Medical University of South Carolina Amendment 3	Solicitation Number	Q191100ADD
		Date Printed	January 3, 2019
		Date Issued	January 3, 2019
		Procurement Officer	Angie DeVeaux
		Phone	843-792-2389
		E-Mail Address	deveauan@muscd.edu

DESCRIPTION: **Fabricate and Install Steel Beam-W8x18**
 USING GOVERNMENTAL UNIT: Medical University of South Carolina

Questions and Answers:

MUSC CHP 1ST FLOOR FOLDING PARTITION
DOOR (ROOM 105)

S201

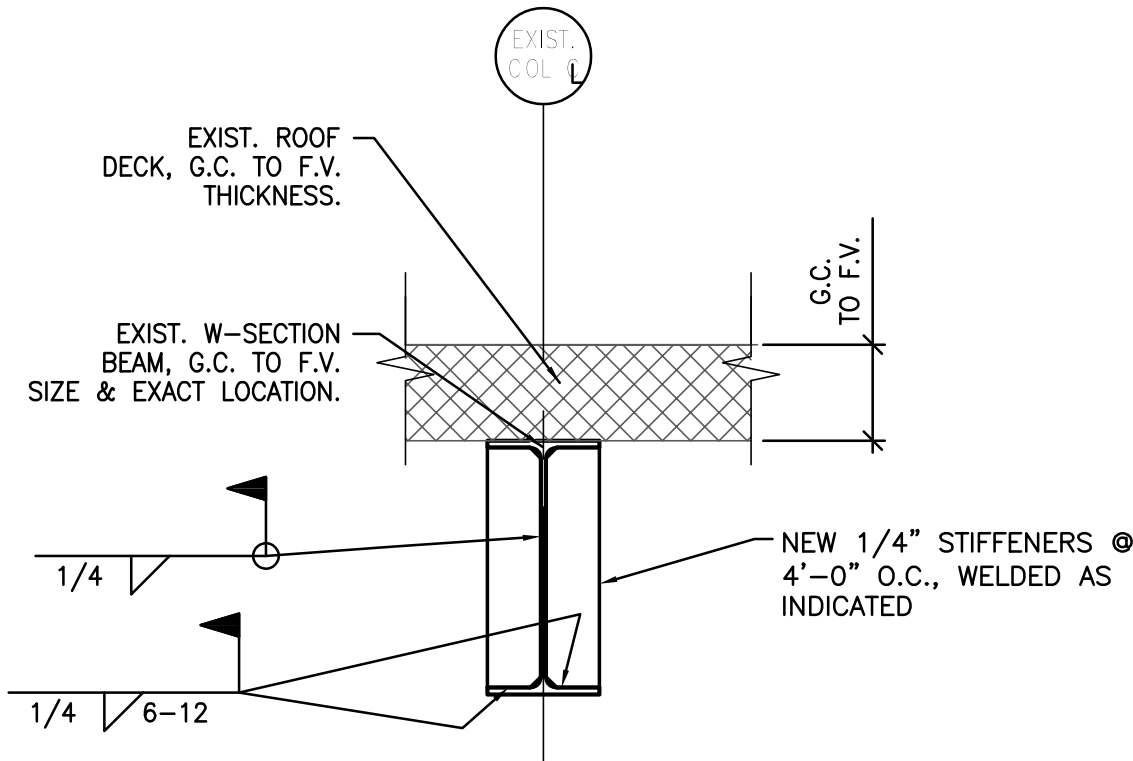
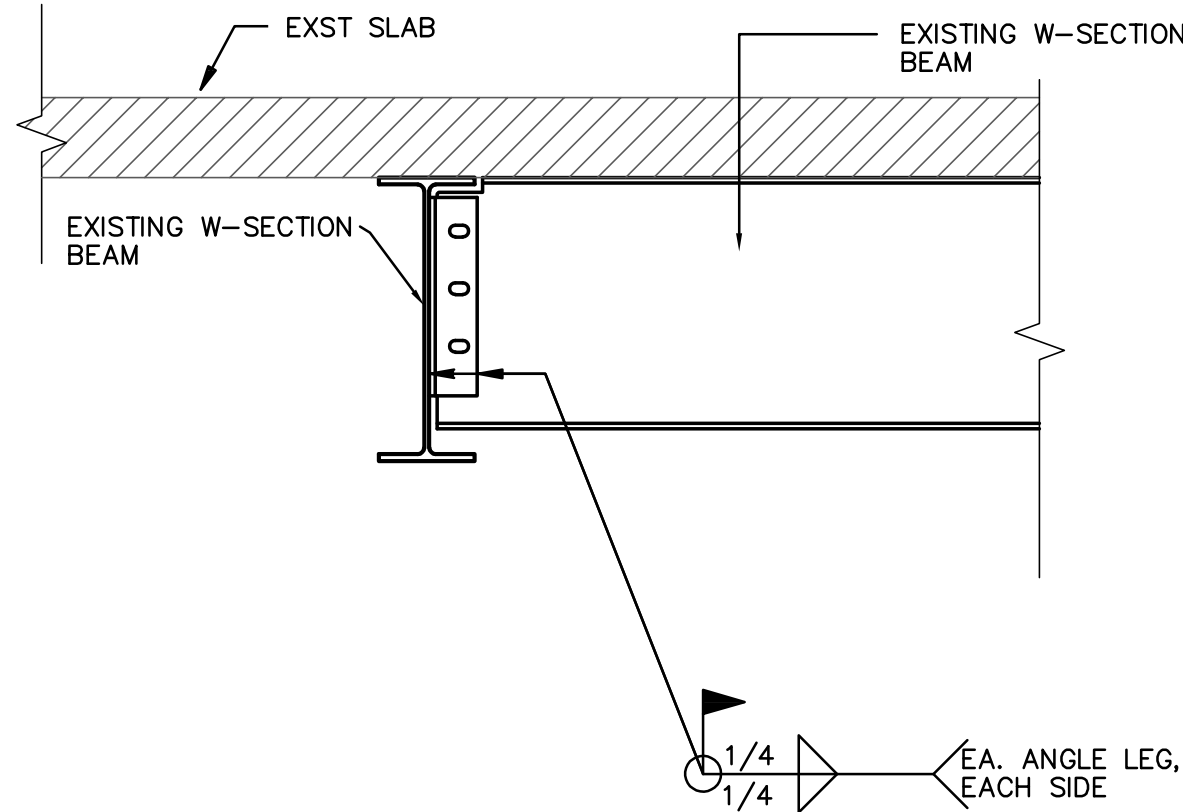
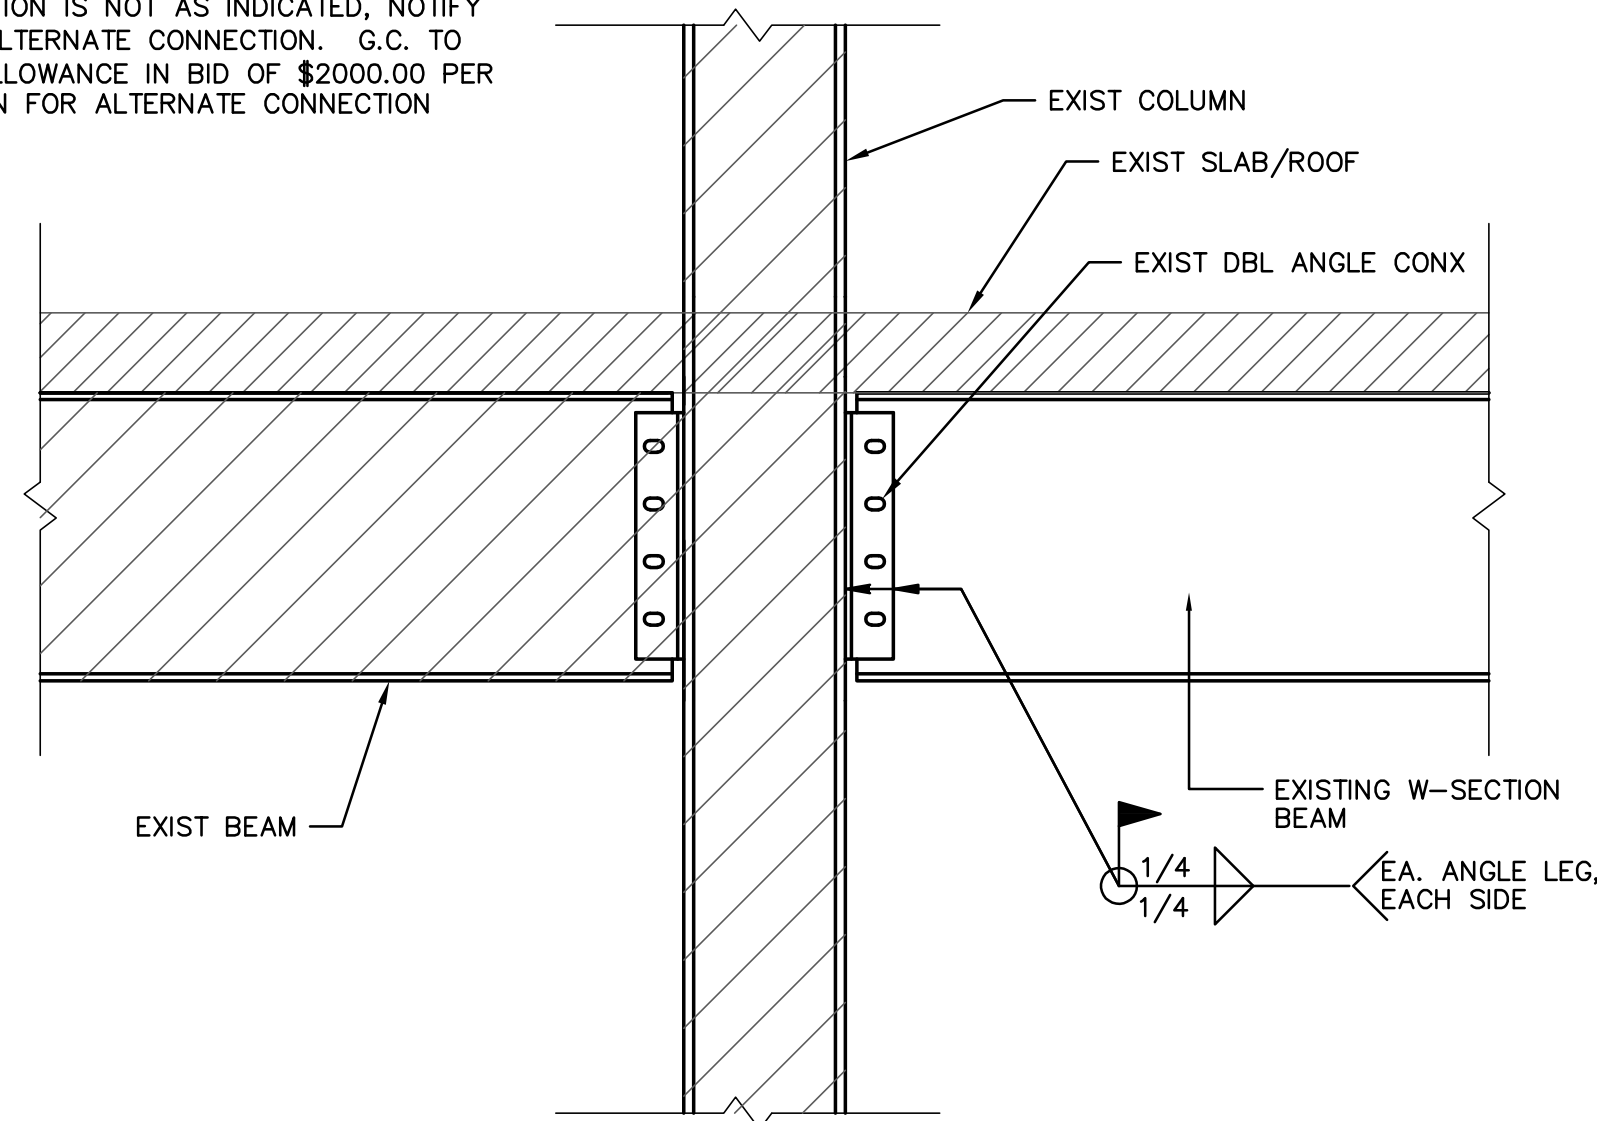
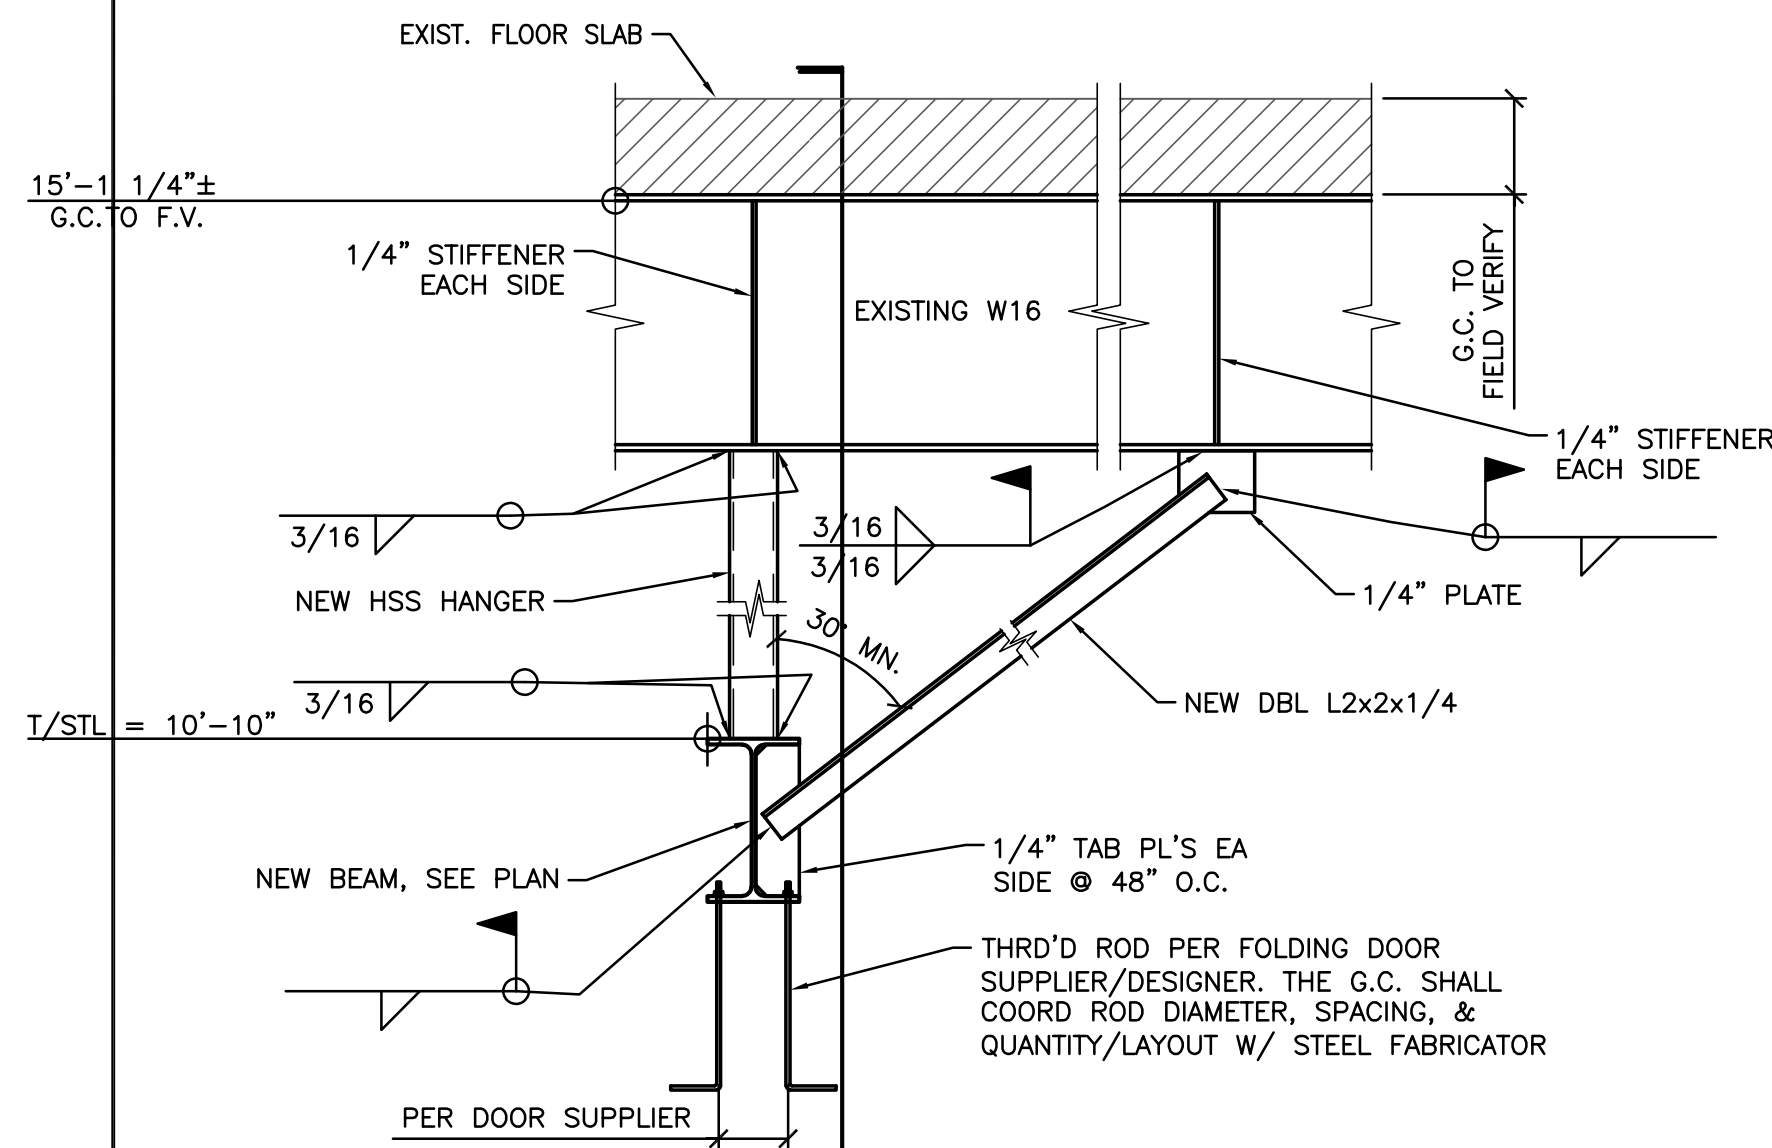
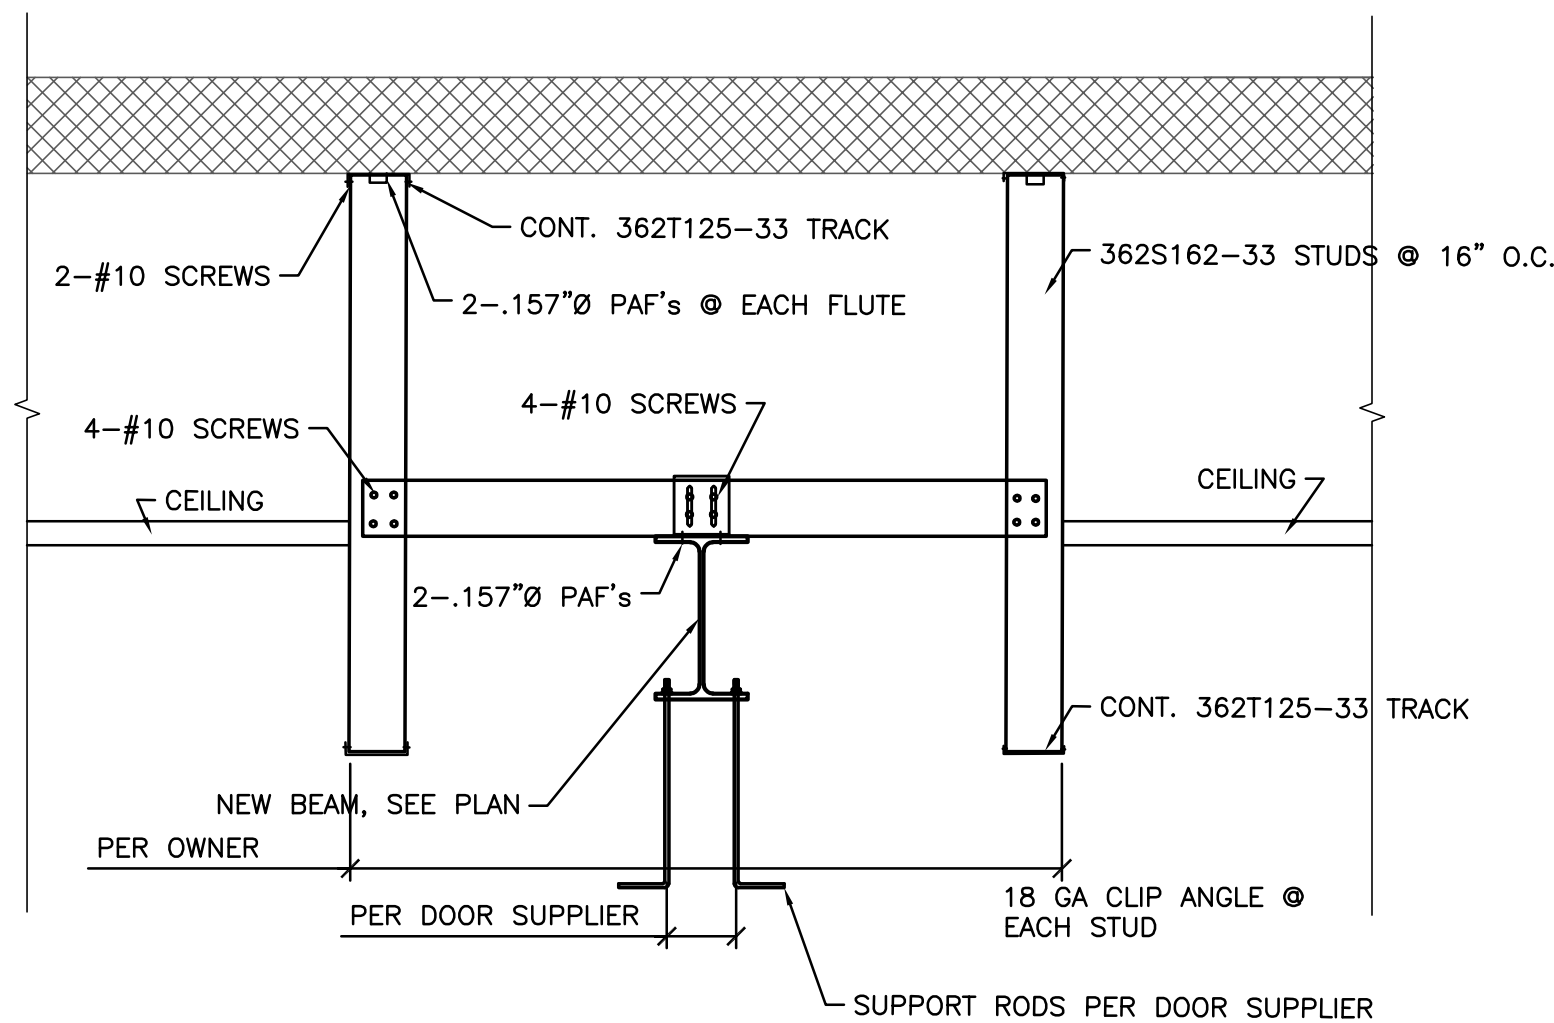
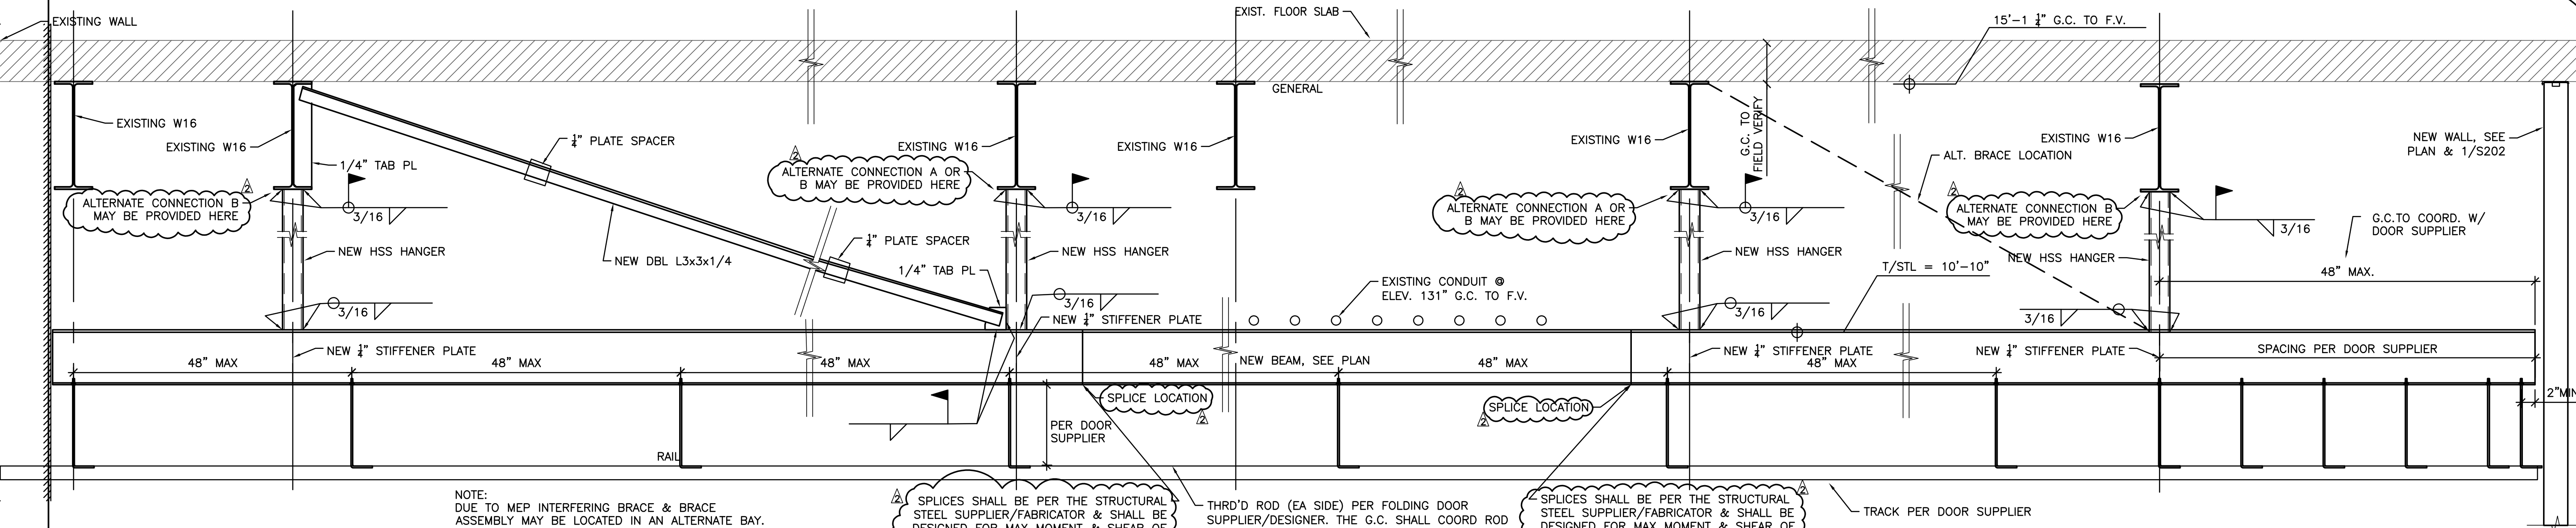
3. If the beam doesn't fist directly underneath the existing beam is there an alternate detail for he hanger?

See attached updated drawing revised 01/17/2019

- **S201 sheet 3 and S202 sheet 4 revised 01/17/2019 alternatives on hangers**
- **S201 sheet 3 revised 01/17/2019 for splice instructions**

SPICES SHALL BE PER THE STRUCTURAL
STEEL SUPPLIER/FABRICATOR & SHALL BE
DESIGNED FOR MAX MOMENT & SHEAR OF
THE BEAM SECTION
